Access Compliance Report

Public Rights-of-Way

(Curb Ramps)

Intersection ID: 10038774	Main Street: STEELE_CREEK_RD	Cross Street: N/A	Location: SE
ADA ID: F2BAE9CC75C1	Ramp Type: BlendTrans2	Initial Pass/Fail: Fail	Overall Compliance: No
		Severity Score: 8.75

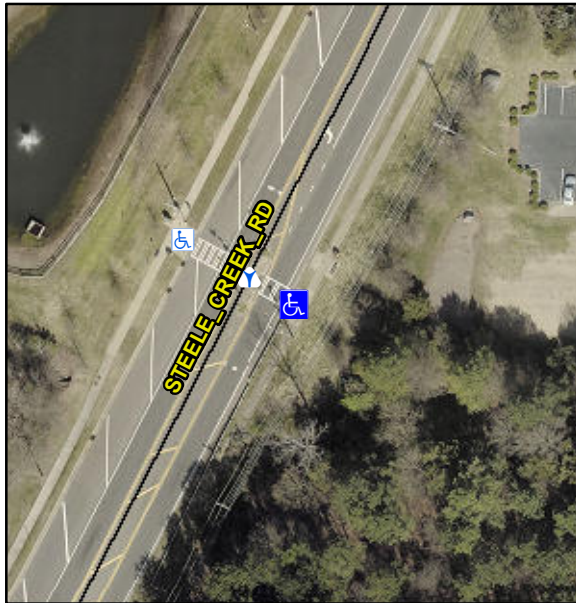
BUSY ROAD, CANNOT GET FRONT PHOTO

Not Found, R304.5.1

N/A	Ramp inside XWalk1?	Yes	N/A	Ramp inside XWalk2?	N/A
	Road Slope (%)	0.7		Clear Space?	N/A
	Road X Slope (%)	9.2	N/A	Clear Space to XWalk (in)	N/A
N/A	Any Obstructions?	N/A	N/A	Storm Grate/Utility Hazard?	N/A
	Obstruction Type			Storm Grate/Utility Type	
		N/A			N/A
			Yes	Surface Condition? (G/P)	Good
			No	Curb Slope (%)	6.9

Remove & Replace Curb Ramp With Two New Directional Ramps or Equivalent.
